Subject: Objection to Identifying Property as Land Affected by Stormwater Overland Flow - Amendment C196 Planning Scheme as SB02

Submission to Amendment C196more

From: [REDACTED]
Sent: Monday, 10 June 2024 9:58 PM
To: Strategic Planning
Subject: Amendment C196 - [REDACTED]

Unacceptable.jpg

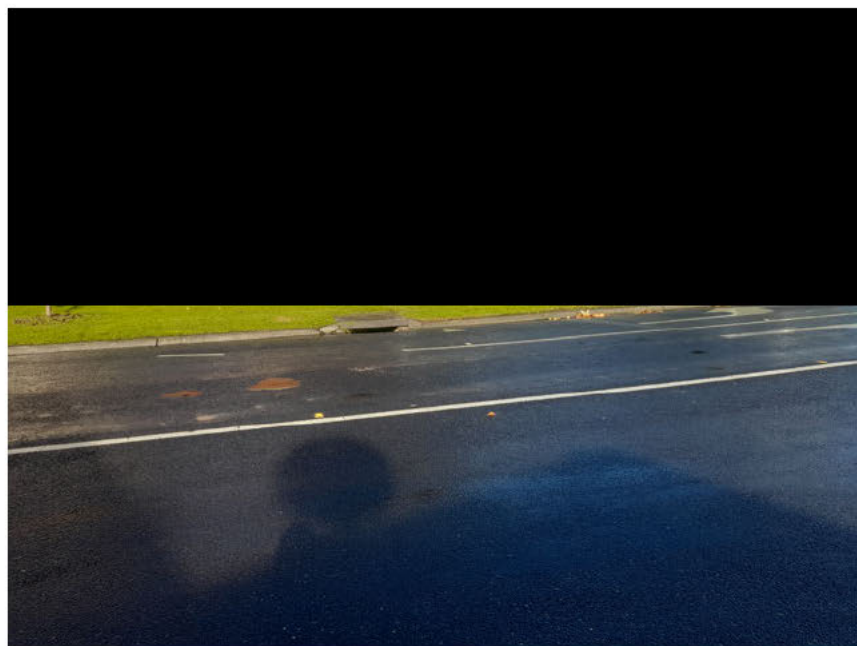
I am writing in relation to the AMENDMENT C196MORE - MERRI-BEK PLANNING SCHEME. INTRODUCTION OF THE SPCEIAL BUILDING OVERLAY - SCHEDULE 2
